**VALENTINE GOLD PROJECT: AMENDMENT TO THE ENVIRONMENTAL IMPACT STATEMENT**

**PART 2**  
**Responses to Regulatory and Public Comments**

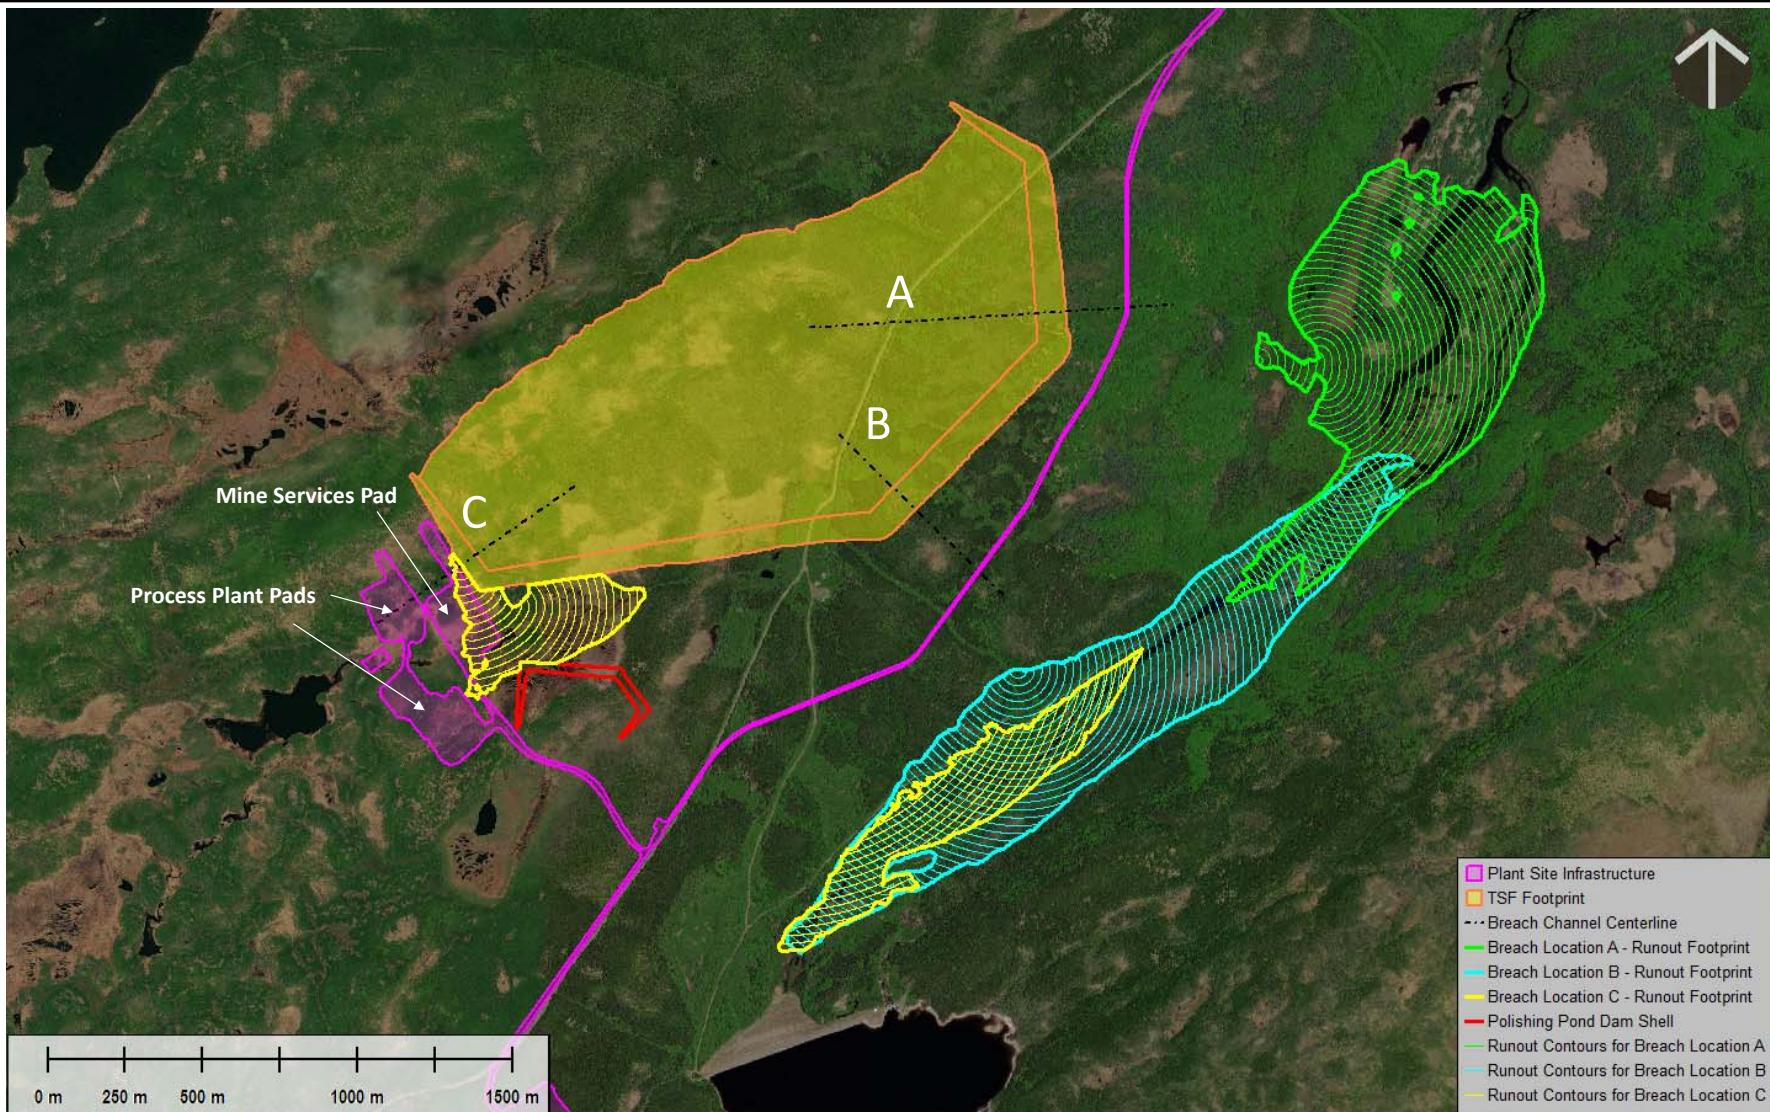
ID:	<b>ECC-30</b>
Expert Department or Group:	Department of Environment and Climate Change- Water Resources Management Division
Guideline Reference:	Section 4.2.1.1- Dam Safety
EIS Reference:	-
Context and Rationale:	BSA1, Attachment 1-A, pg. 26 “A relocation of the Process Plant 200 m southwest or 500 m northwest could prevent it from being inundated...” “The depth of tailings at the toe of the TMF’s South Dam is approximately 0.5 m. Given the slope and gross width of the rockfill dam, the net effect of any scour in the vicinity as tailings are deposited is expected to be minor. Consequently, the rockfill dam shell is unlikely to be affected.”
Information Request:	Has relocation of the Process Plant been looked at? The effect of the scour from the tailings release on the South Dam should be properly analysed.

Response:	<p>It is important to note that a dam breach at Location C (the southwest end of the tailings management facility [TMF]) has a substantially lower potential of occurrence than any other location along the tailings impoundment dam due to no water ponding at this location, and a lower dam height. As with any Dam Breach Assessment (DBA), a failure must be assumed and in this case the failure mode is strictly geotechnical, rather than water-related (flooding causing overtopping, piping, etc.). Marathon is continuing to assess the potential impact of the dam breach at the southwest end of the tailings impoundment. The updated DBA (refer to ECC-23), which includes the latest process plant area arrangement, shows that the tailings inundation does not reach the process plant pad, however, it does inundate a portion of the mine services pad (see Figure ECC-30.1). Marathon will consider options to reduce or eliminate this potential (e.g., raising the elevation of the mine services pad to prevent inundation) and/or use of dam instrumentation to warn of a potential failure as geotechnical failures can be progressive, and movements can be detected prior to large-scale failure.</p> <p>The scour potential along the southern extent of the TMF dam is not considered critical as the velocity of moving tailings without additional water (from the tailings pond) will be relatively slow. Marathon will continue to assess this issue as the TMF design advances. If scour along the toe is of potential concern, the best solution is expected to be placement of large diameter waste rock blocks to prevent scour along the toe.</p>

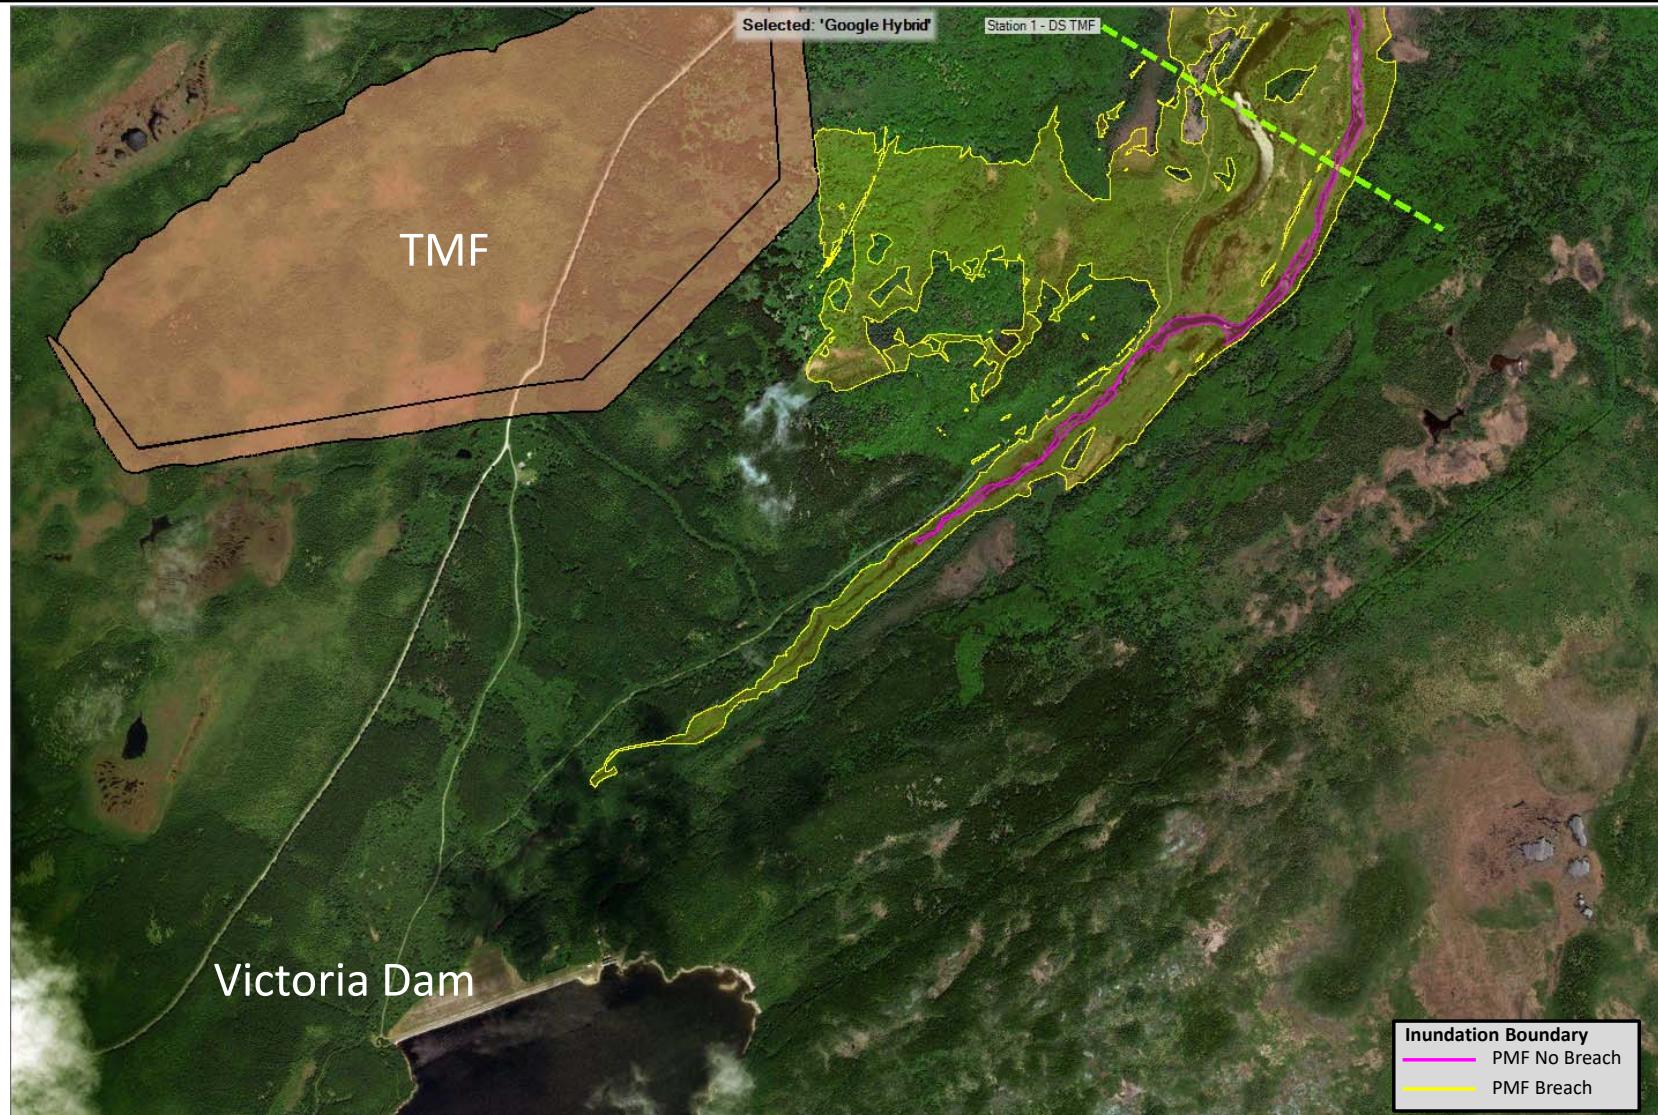
<b>ID:</b>	<b>ECC-32</b>
Expert Department or Group:	Department of Environment and Climate Change- Water Resources Management Division
Guideline Reference:	Section 4.2.1.1- Dam Safety
EIS Reference:	-
Context and Rationale:	-
Information Request:	BSA1, Attachment 1-A, pg. 38  In Figure 5, the flow path for the South Dam does not show the flow going upstream towards the toe of the Victoria dam as discussed in the sections of the preceding report.
Response:	Based on the current tailings management facility (TMF) design and operation, the peak water and tailings discharge from the TMF under a breach is now at Location A. The impacts of the Location A breach in the Victoria Dam area are shown in Figure ECC-32.1.
Appendix:	None

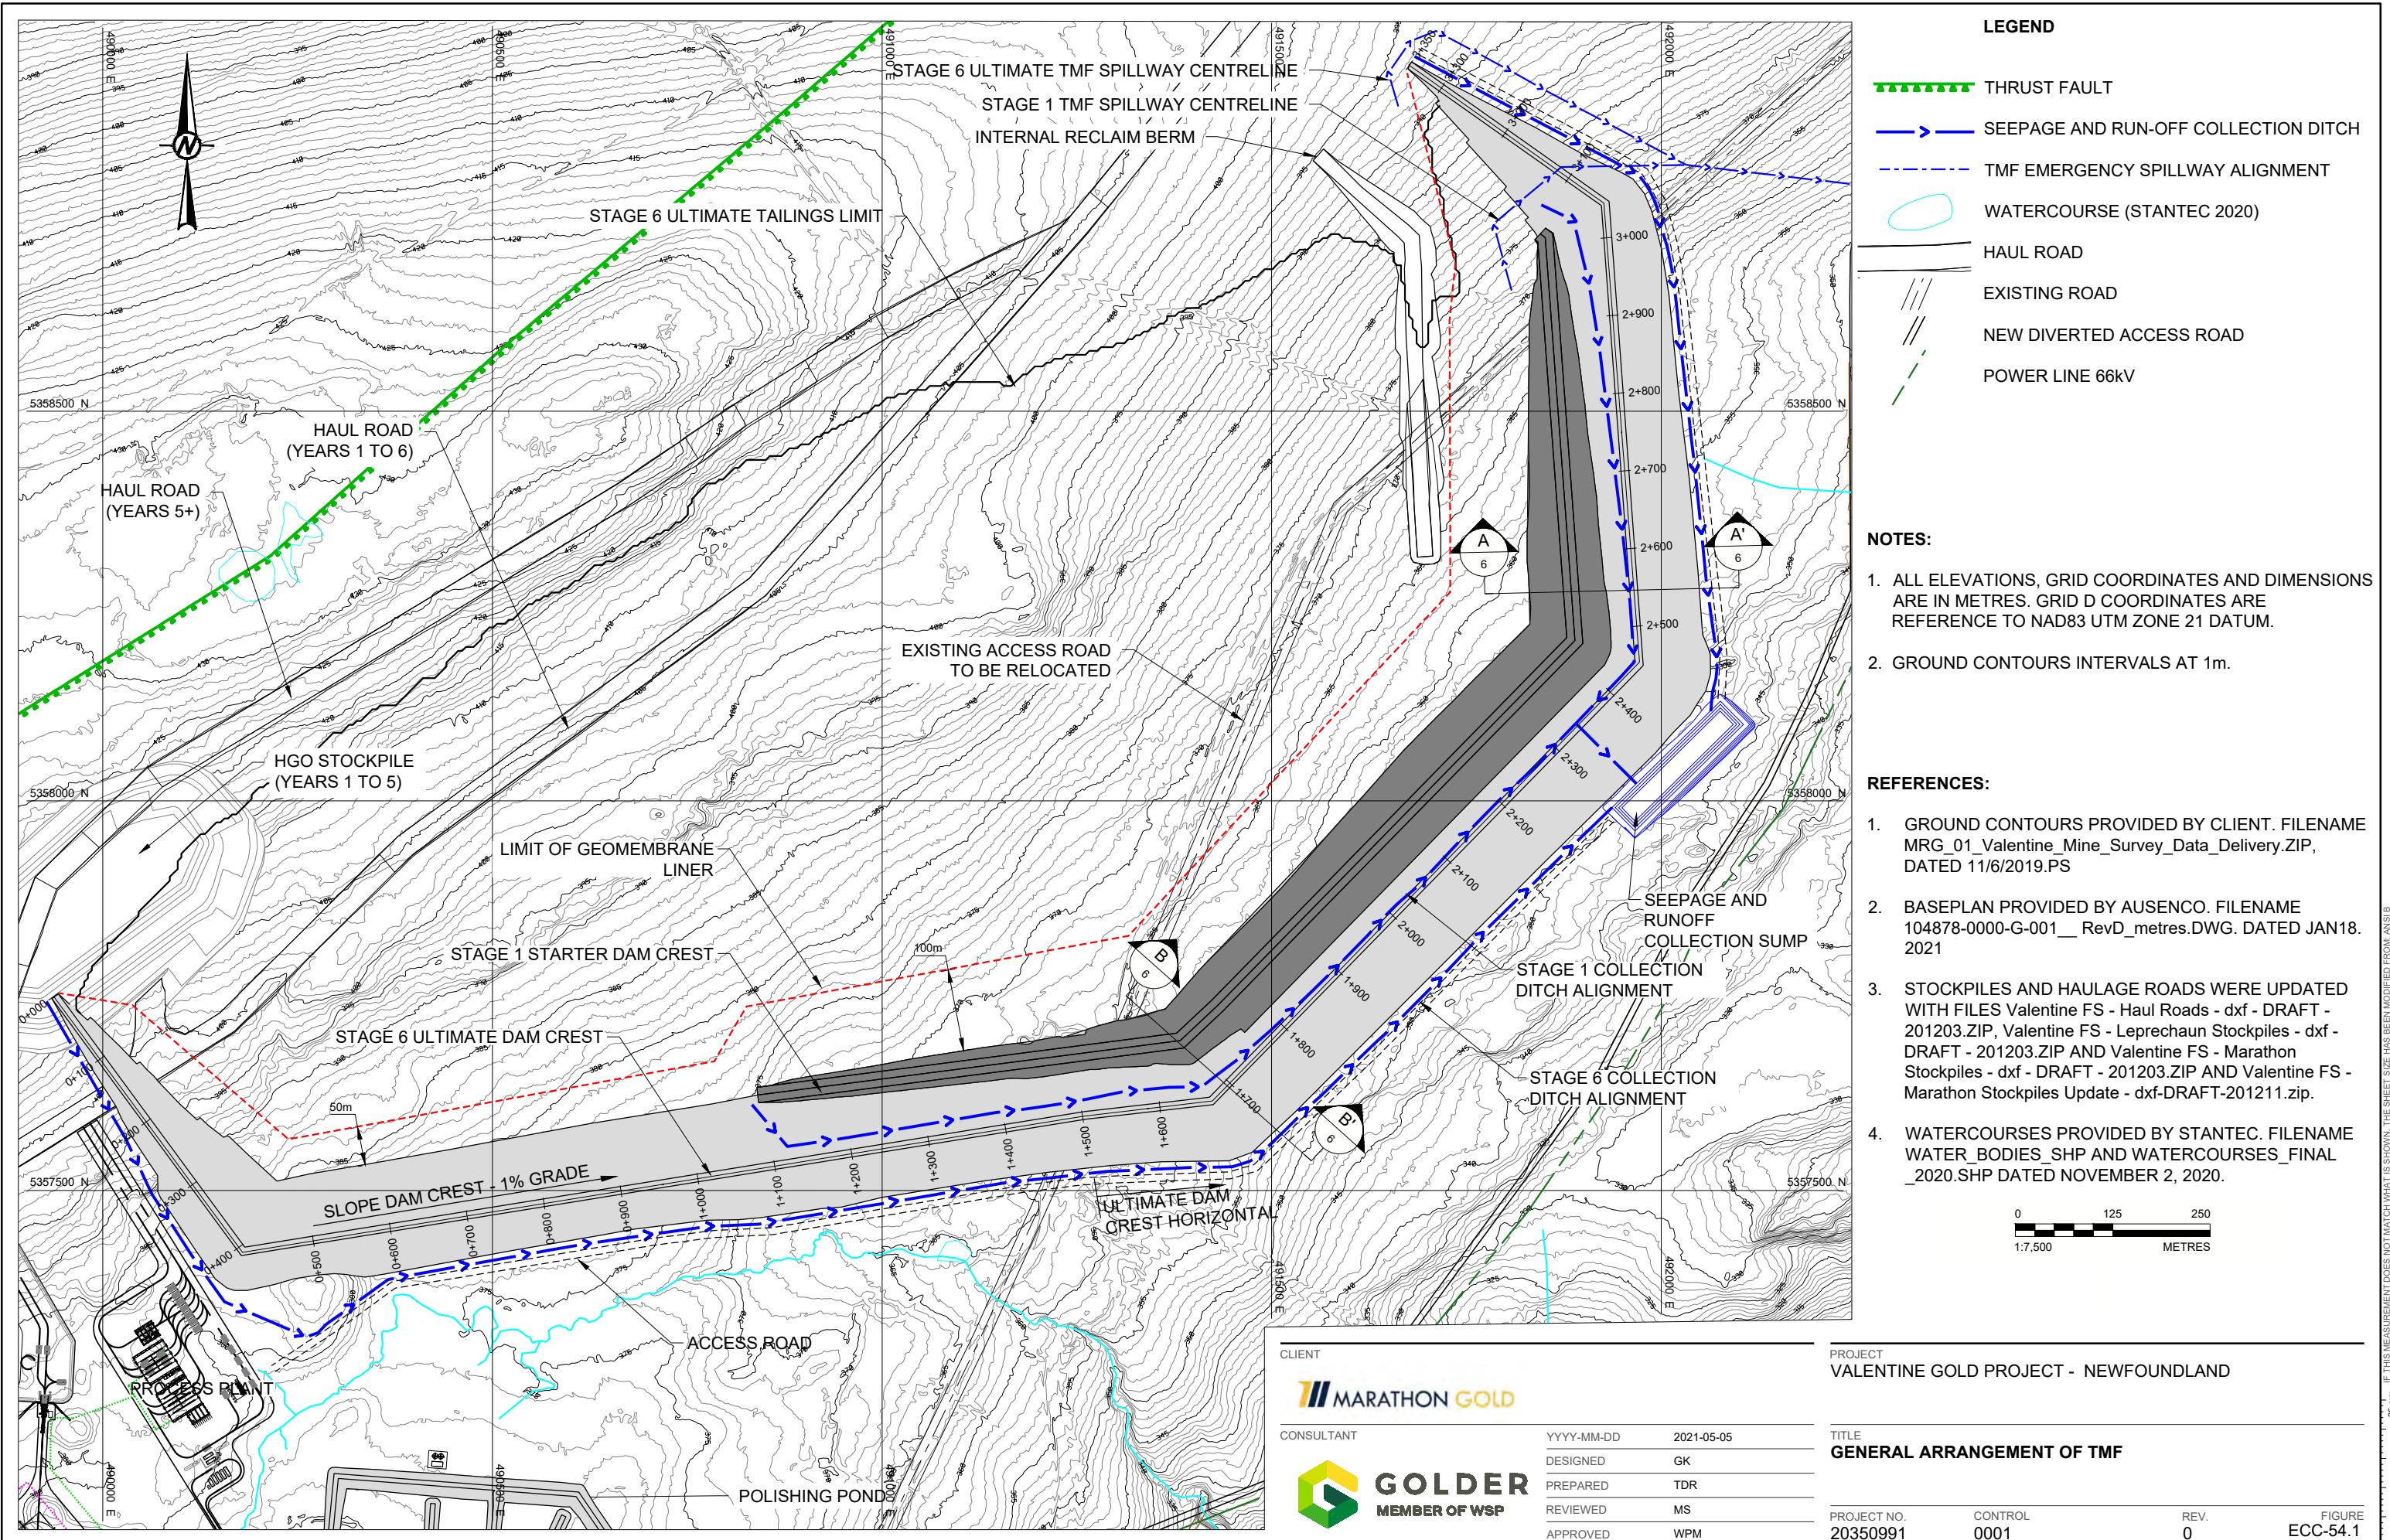
ID:	<b>ECC-54</b>
Expert Department or Group:	Department of Environment and Climate Change- Water Resources Management Division
Guideline Reference:	Section 4.2.1.1- Dam Safety
EIS Reference:	-
Context and Rationale:	Appendix 7A, pg. 31, Figure 4 “Toe seepage from the tailings pond will be intercepted by seepage collection ditches along the down gradient perimeter of the dam.”
Information Request:	Will the seepage ditch be fixed in location or continue to move downstream of the toe for each raise of the tailings dam? If it is fixed, it will be around 150 m downstream of the toe of the Stage 1A tailings dam (Figure 4). Will the ditch at this distance be able to capture seepage of the earlier tailings dam phases? Or is the ditch ~10 m downstream of the toe of each dam raise (based on distance indicated in Figure 4)? There should be some separation between the dam toe and the seepage ditch so as not to affect the stability of the dam.

Response:	The seepage and run-off collection ditch system will be constructed in Stages 1, 2, 3 and 5, moving downstream with subsequent raises of the dam, and remaining in proximity to the dam toes in order to effectively capture most of the seepage. Ditches constructed in Stage 3 will also be suitable for Stage 4. Ditches constructed in Stage 5 will also be suitable for Stage 6. The locations of the Stage 1 (starter) and Stage 5 (ultimate) ditch alignments are shown on the Figure ECC-54.1. The ditches are shallow in depth, will be located at a suitable offset distance from the downstream toe that will not impact the overall stability of the dam.
Appendix:	None
